ADDENDUM #1

Re: Maine Department of Agriculture, Conservation, and Forestry
Bureau of Parks and Lands
Camden Hills State Park Water System Upgrades
Camden, Maine

From: Haley Ward, Inc.
One Merchants Plaza, Suite 701
Bangor, ME 04401

Owner Project No:
BGS Project No: 3464
Project No: 14641.001

TITLE
SITE OVERALL PLAN

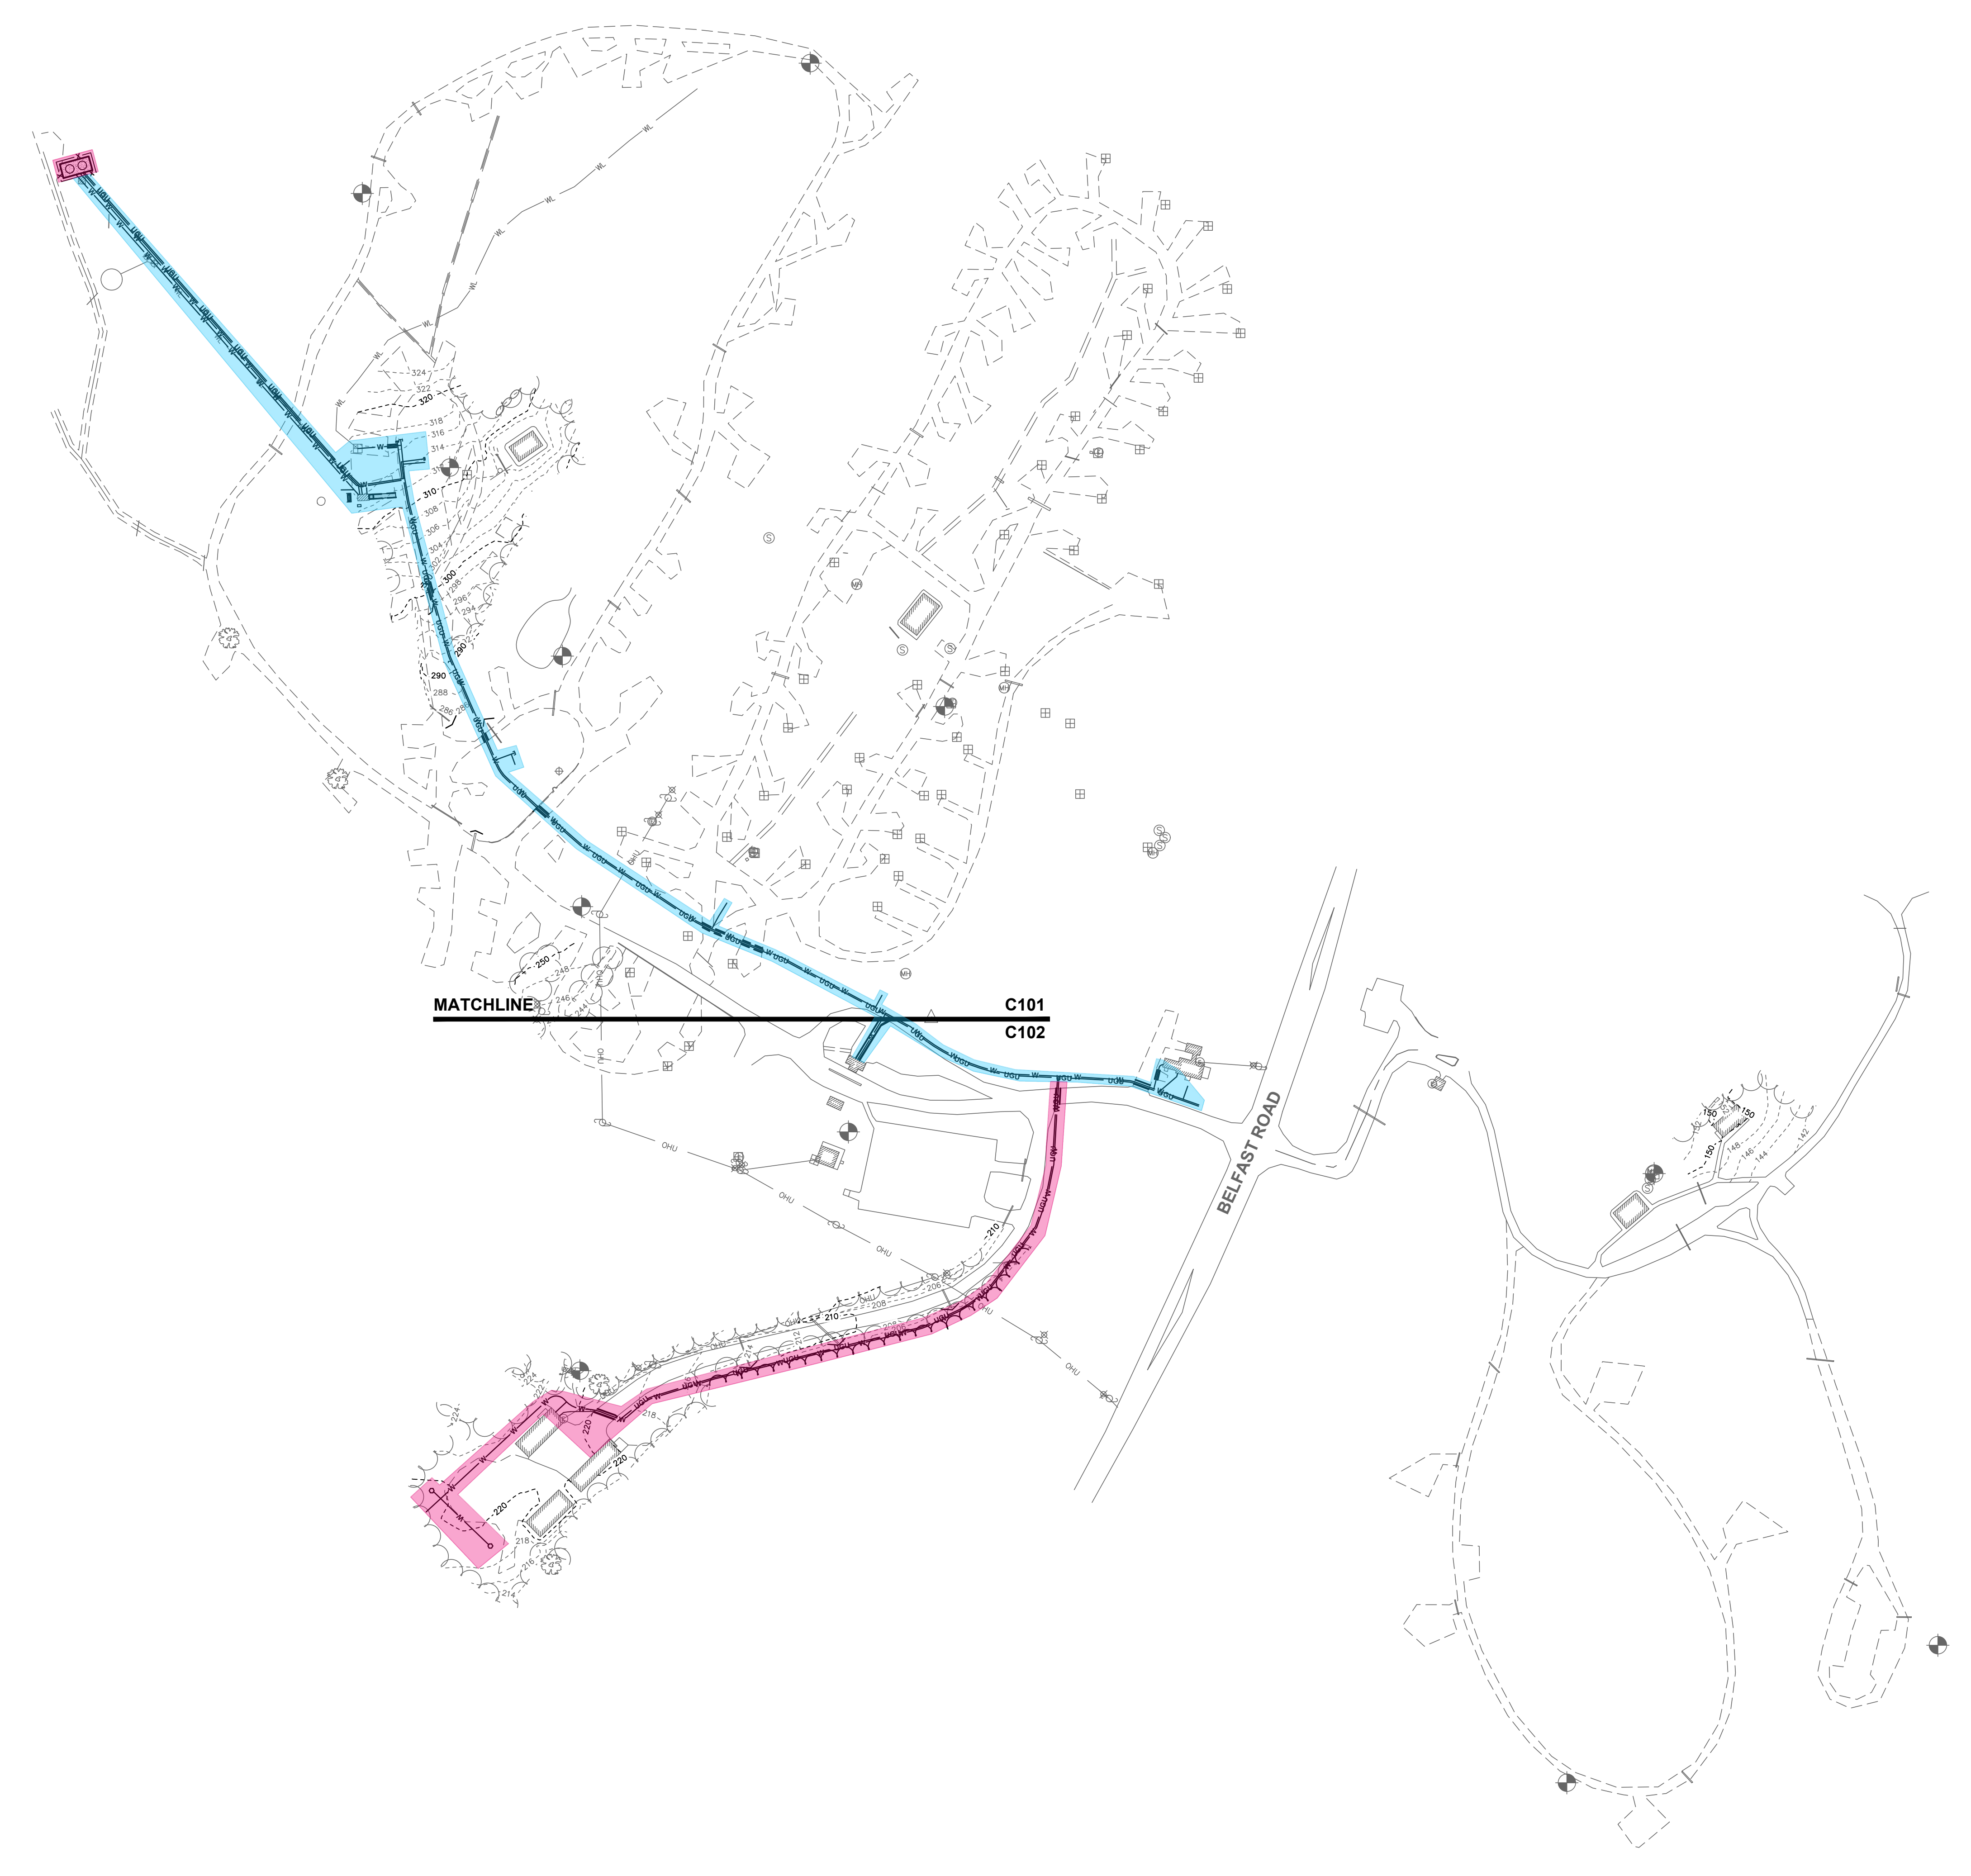
Drawing Sheet C100 has been updated to show the revised layout of the proposed water distribution piping around the existing maintenance shop building. The proposed water spigot adjacent to the existing parking lot has also been removed from the Drawing Sheet.

TITLE: SITE UTILITY PLAN

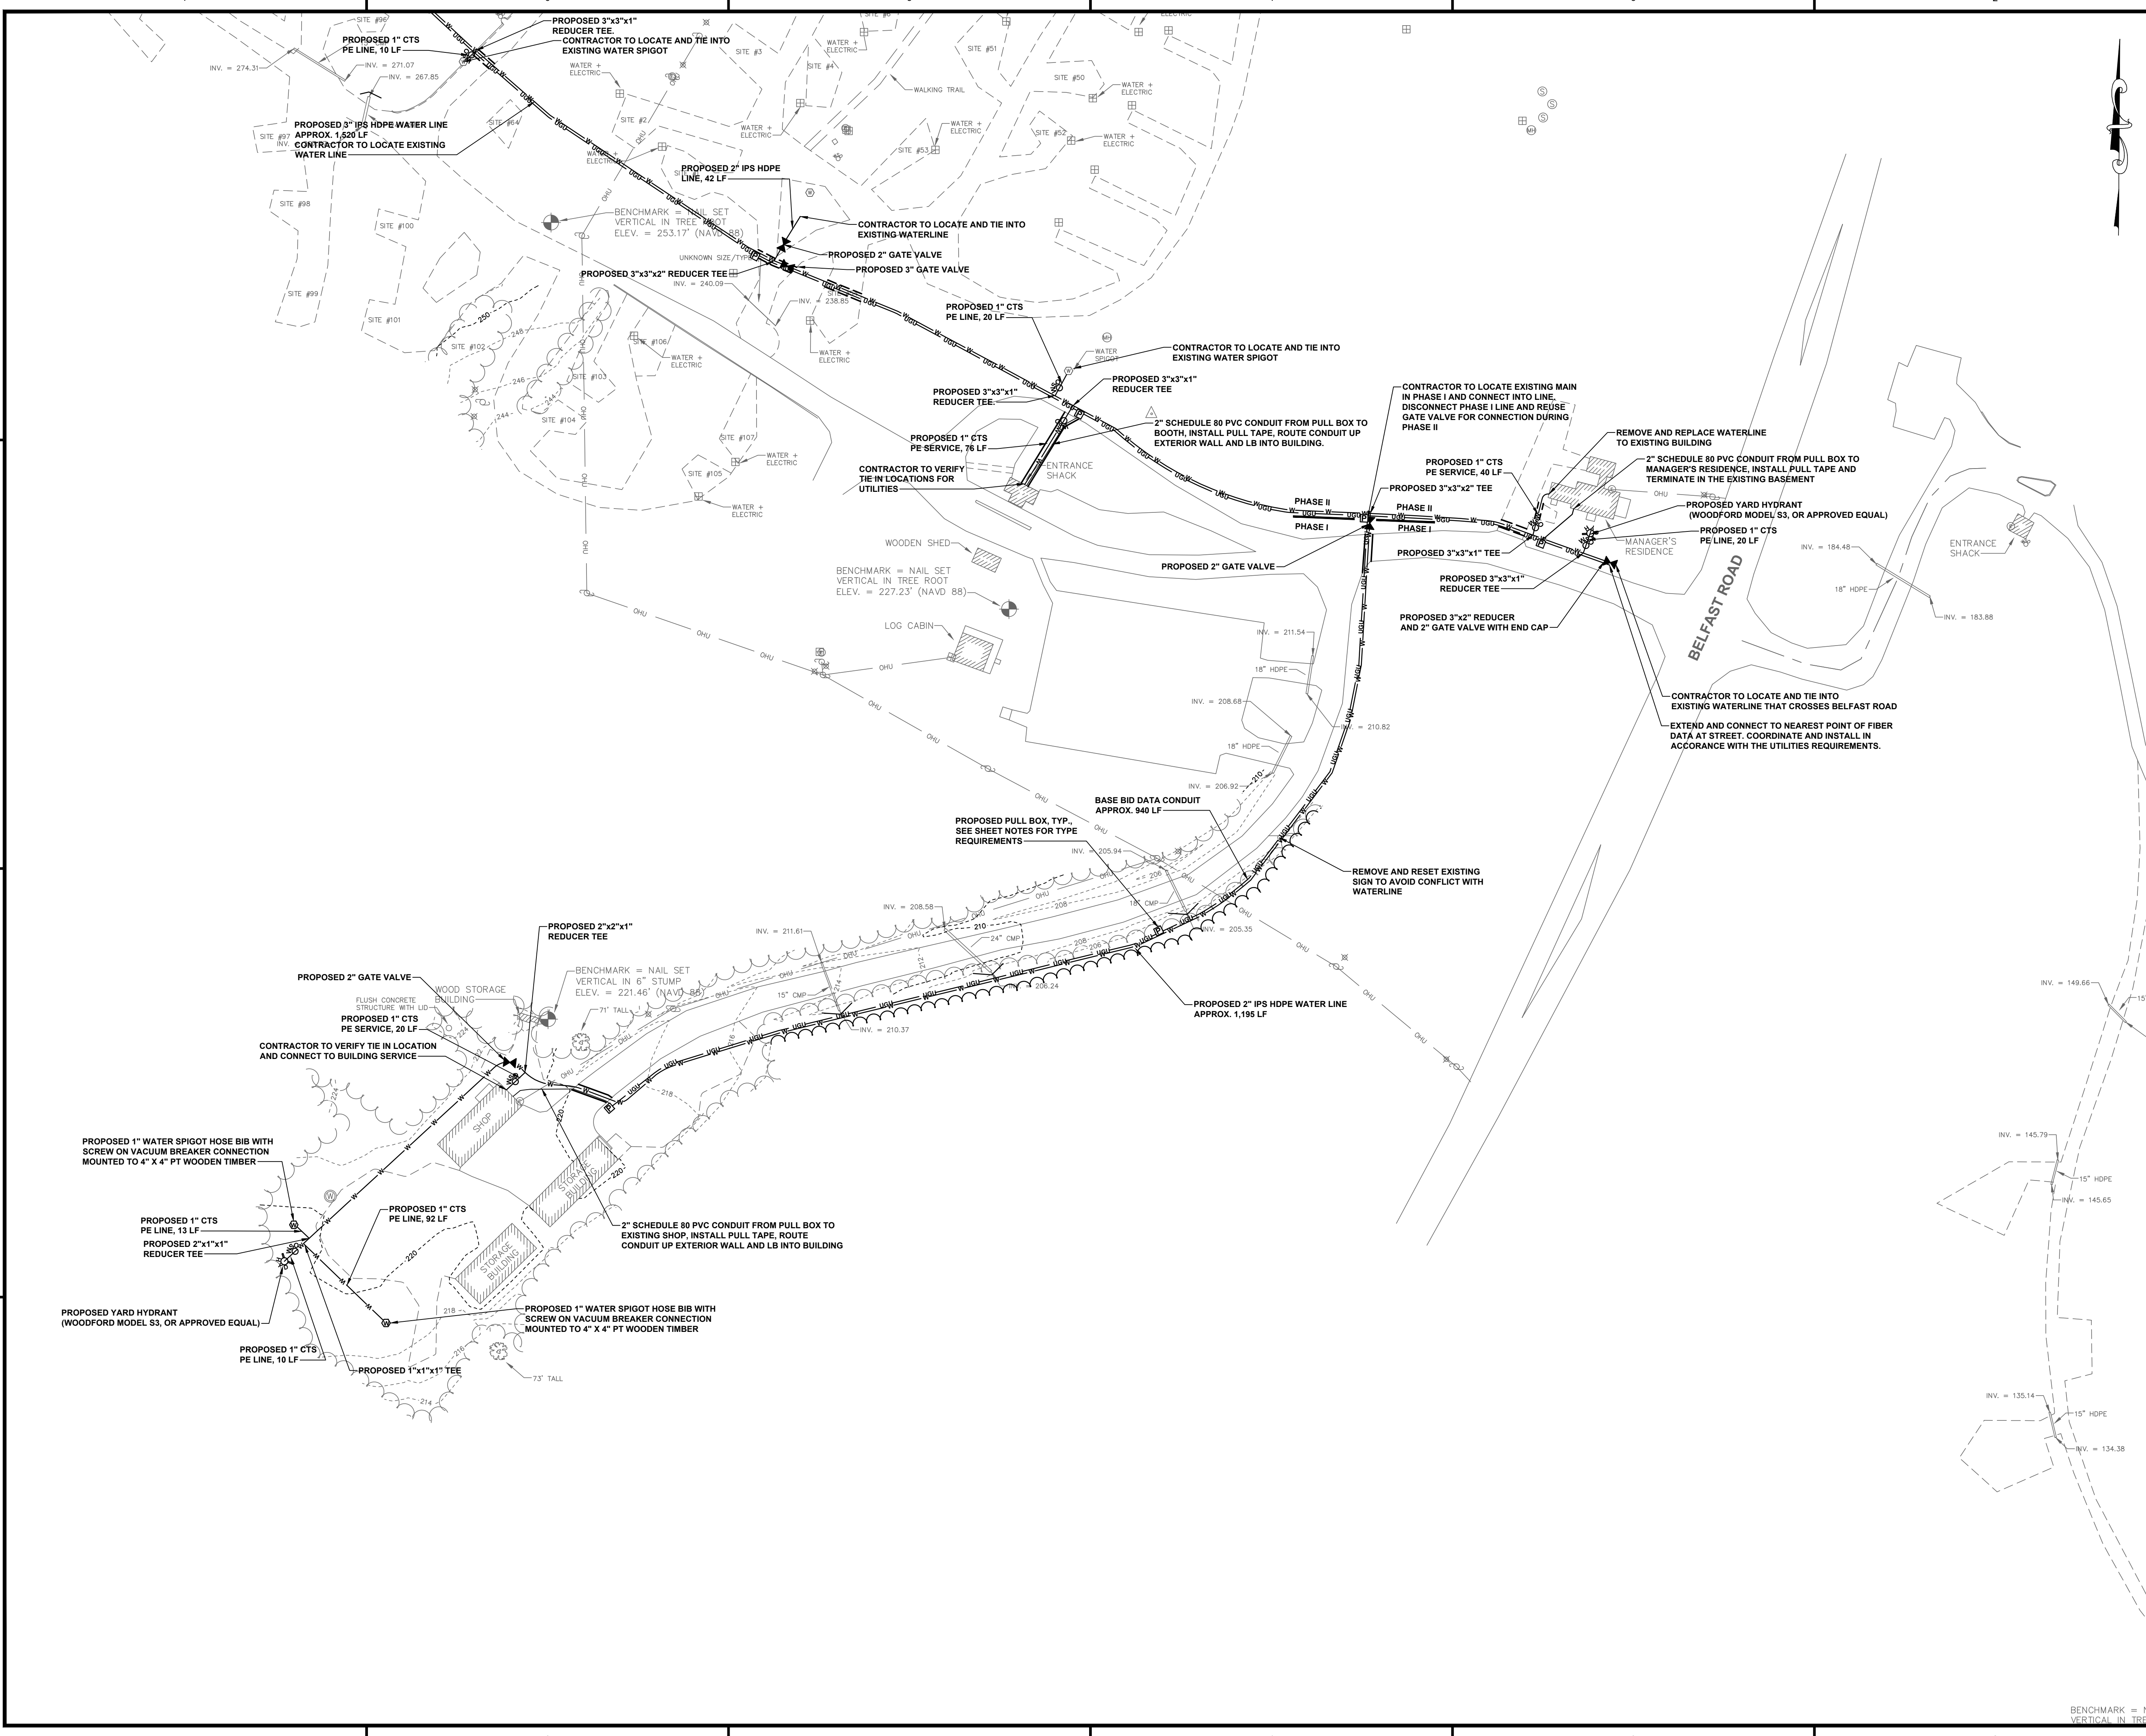
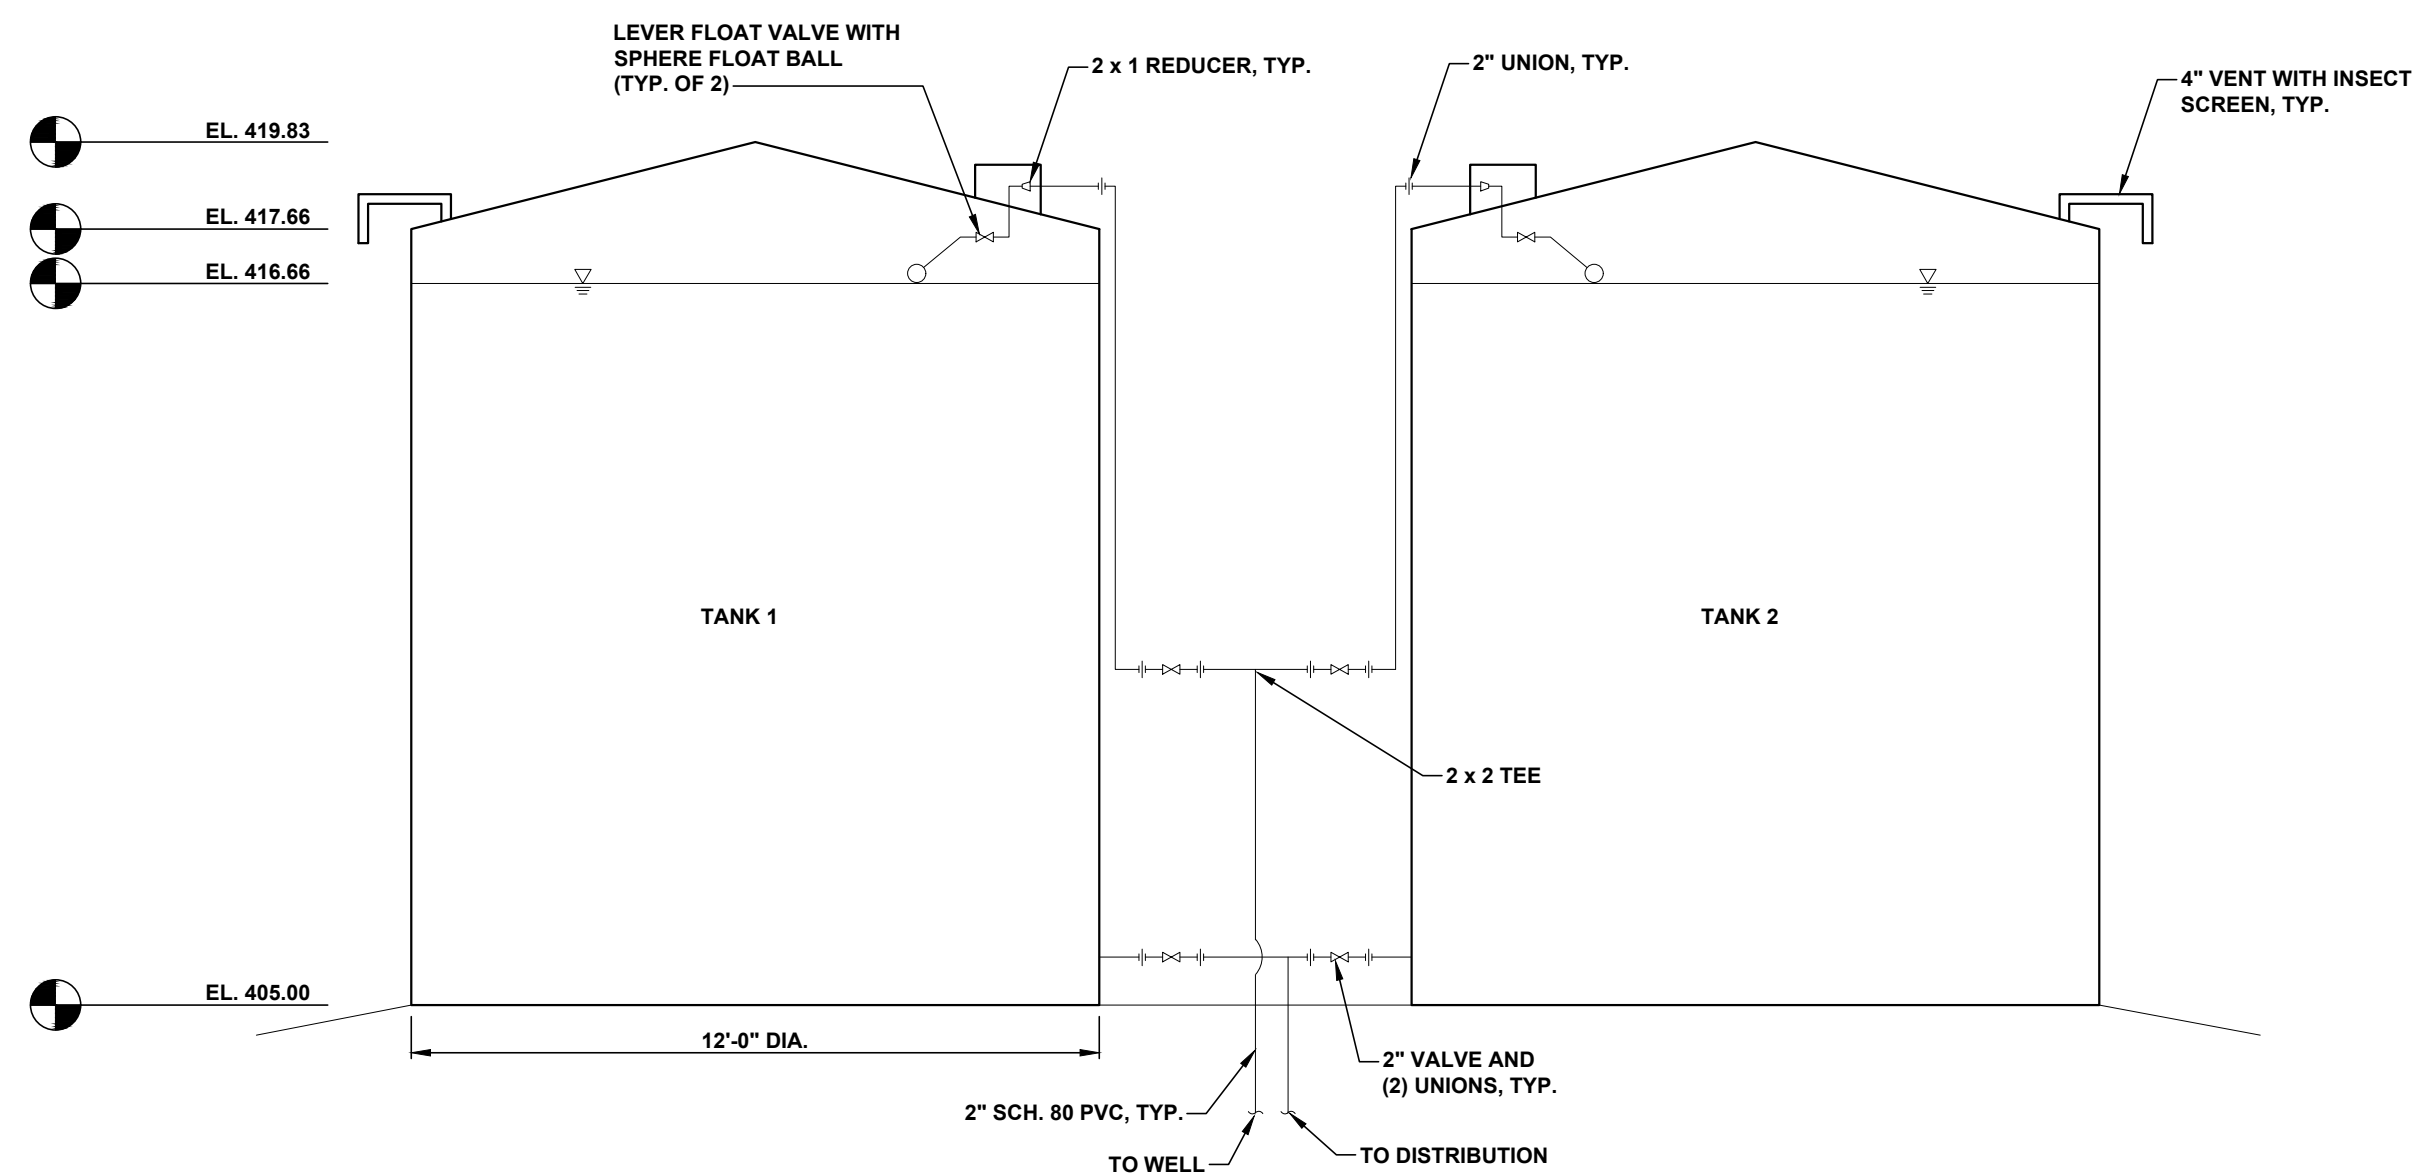
Drawing Sheet C102 has been updated to show the revised layout of the proposed water distribution piping around the existing maintenance shop building. The proposed water spigot adjacent to the existing parking lot has also been removed from the Drawing Sheet.
